ADDENDUM NO. 4

04/15/2026

YWCA OF GRAND ISLAND WYANDOTTE RENOVATION

315 WYANDOTTE ST

4 PLUMBING RISER - KITCHEN

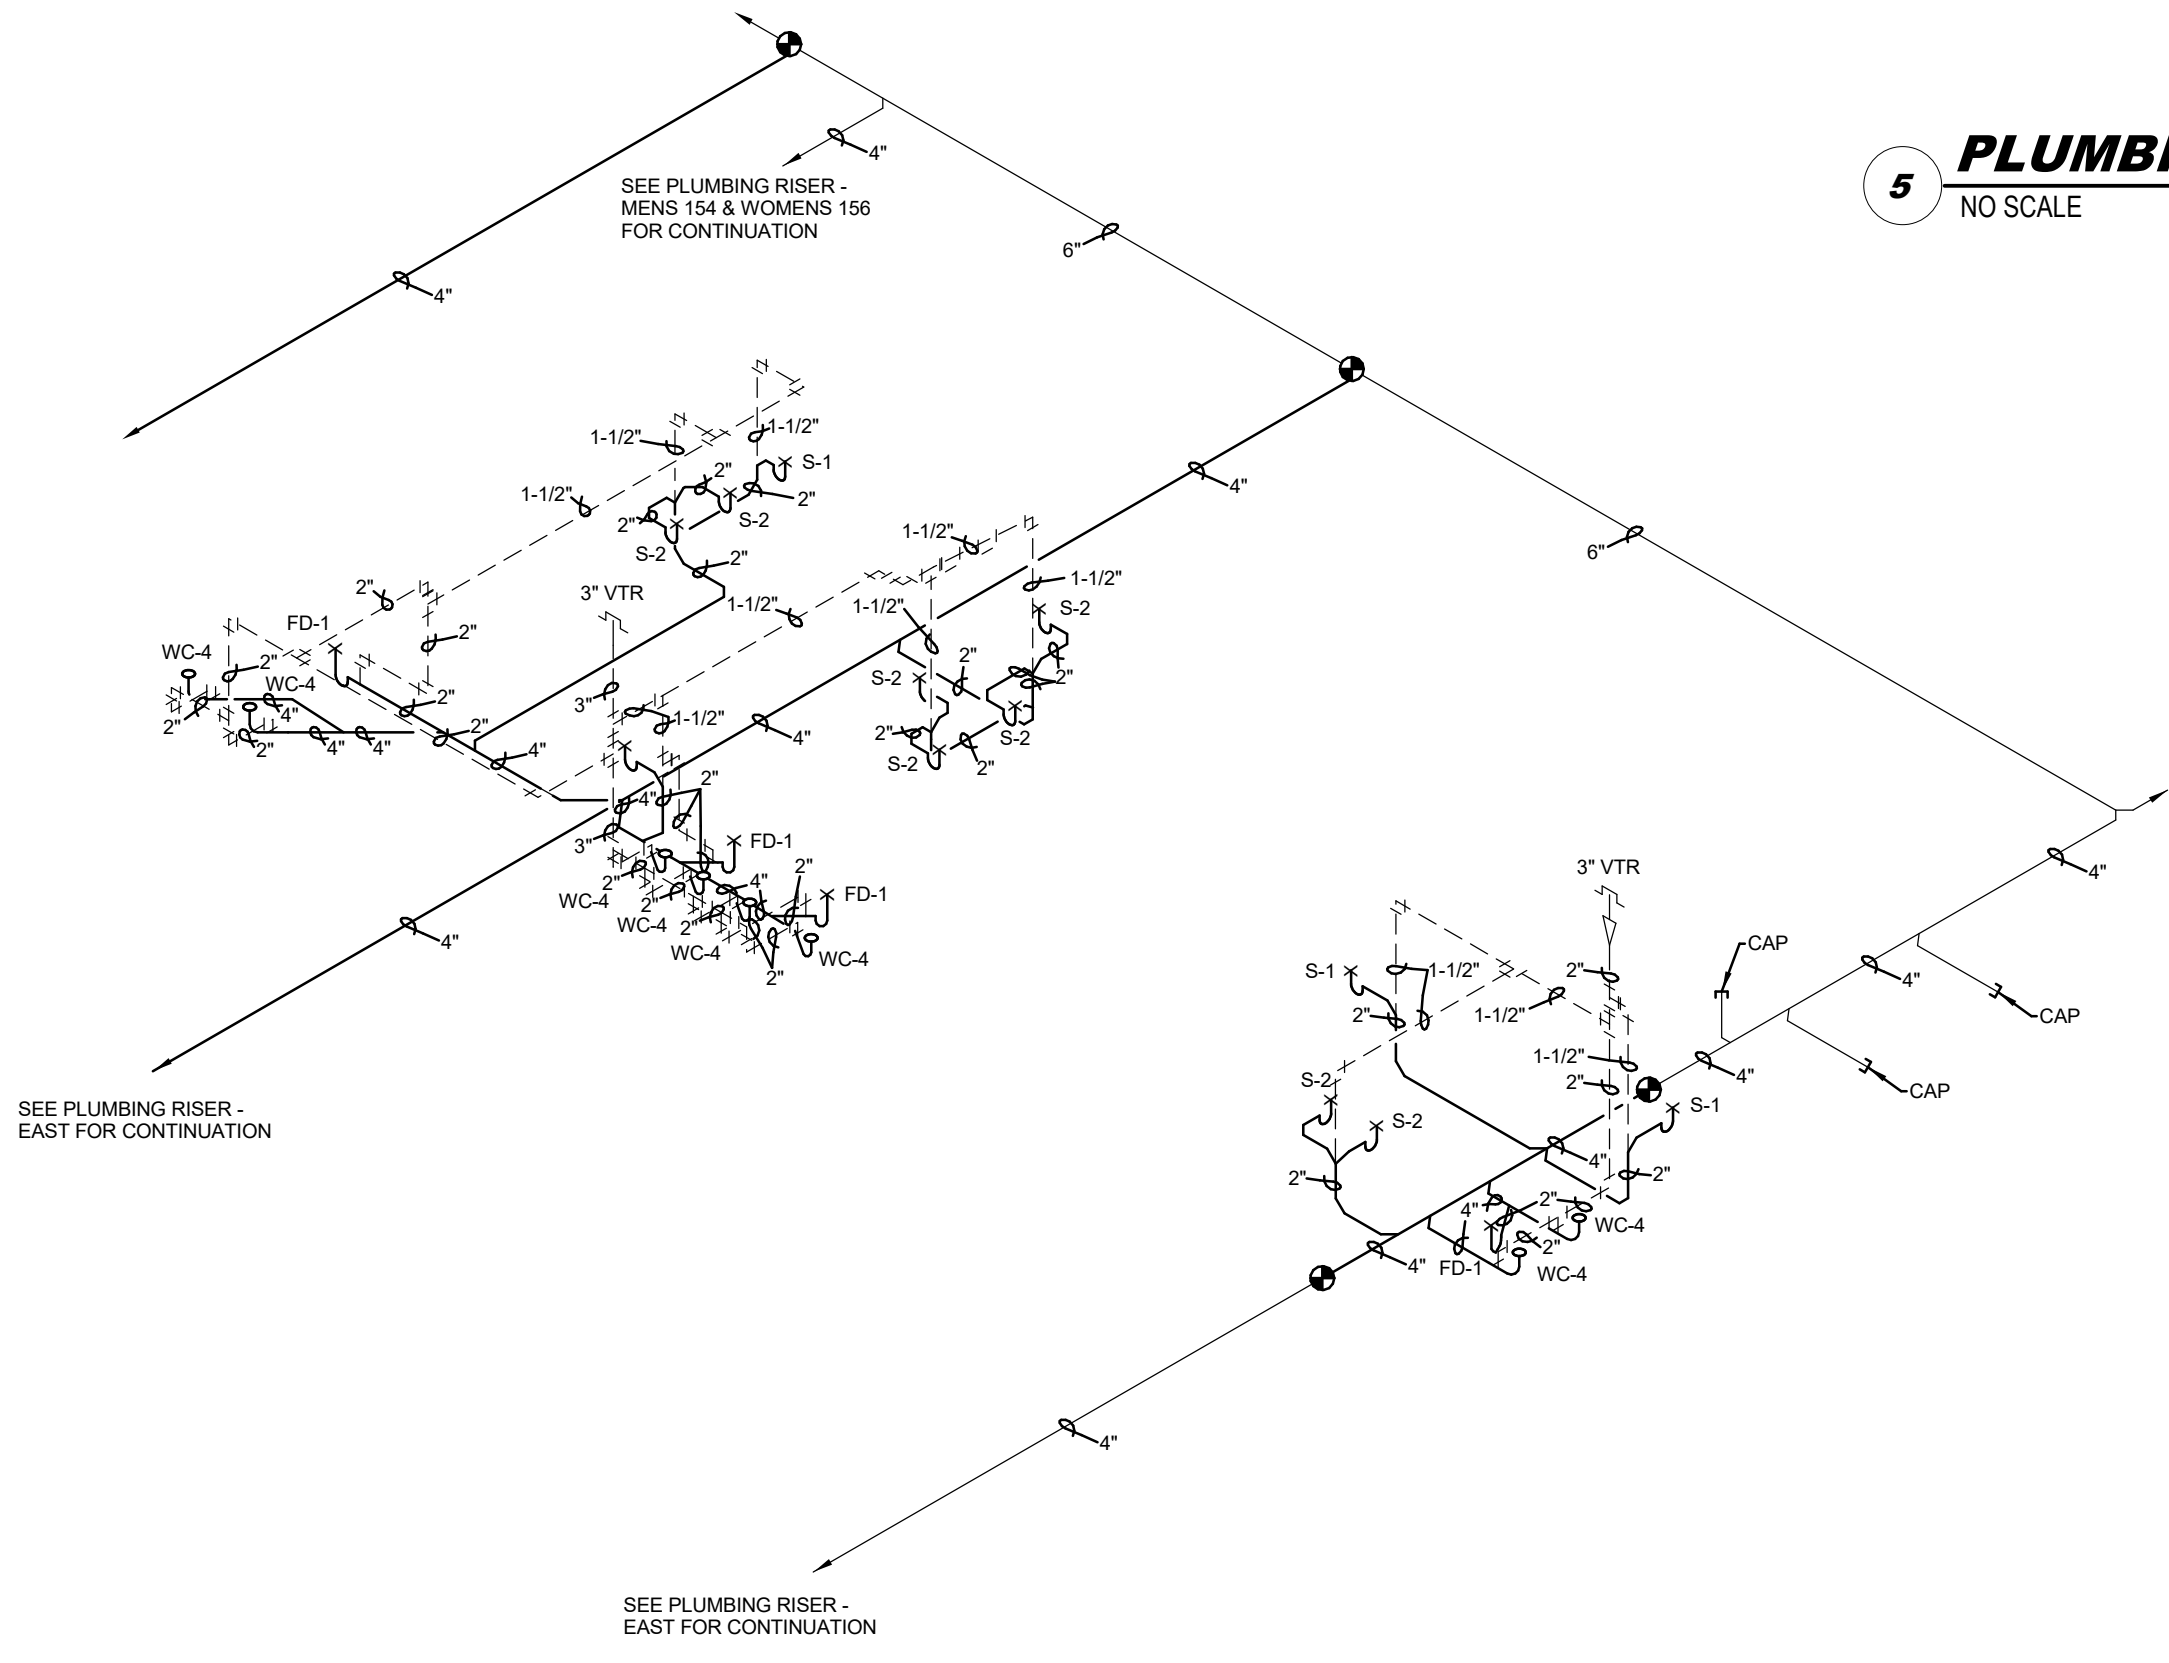
5. Sheet M6.00 Mechanical Risers
 - a. See sheet M6.00 for changes to Plumbing Riser – Mens 154 / Womens 165.
